CITY OF VANCOUVER  
DEVELOPMENT, BUILDINGS, & LICENSING

DEVELOPMENT PERMIT STAFF COMMITTEE  
MEETING  
March 30, 2022

1075 Nelson Street (COMPLETE APPLICATION)  
DP-2021-00589 – CD-1 (Pending Enactment)

Figure 3: DP Submission (Sep 2021)

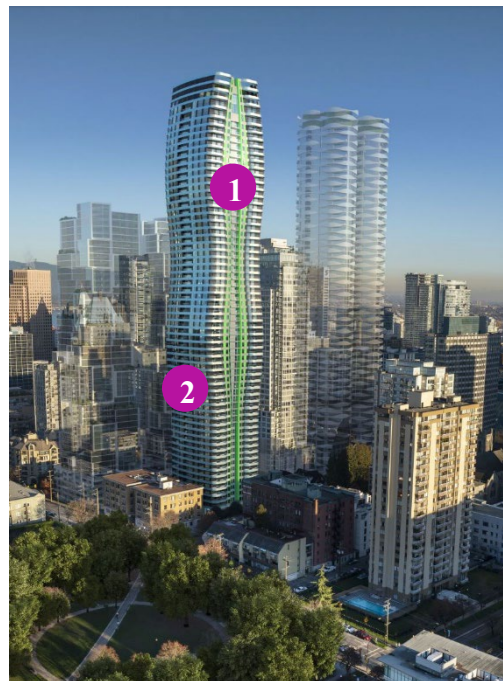
1. Simplifying the floorplate and gap to reduce massing and increase setbacks.
2. Relocating the outdoor amenity to the rooftop and sculpting the crown.
3. Revisions to materiality and how the building connects to the ground.
4. Improvements to mid-block connector to be an active pedestrian walkway.
5. Revisions to landscape at public realm interface to the lane.

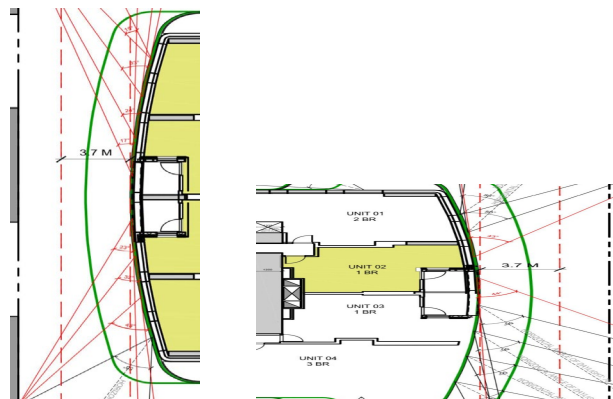
A.1.13 confirmation of compliance with Horizontal Angle of Daylight (HAD) per Section 7 of the pending CD-1 as follows:

- i. illustrate daylight planes horizontally from the bottom of each habitable room window;

**Note to Applicant:** Correct illustrations of plane/s extending from exterior of balconies. A variance to HAD distance requirements to a minimum of 3.7 m (12.14 ft.) may be supported.
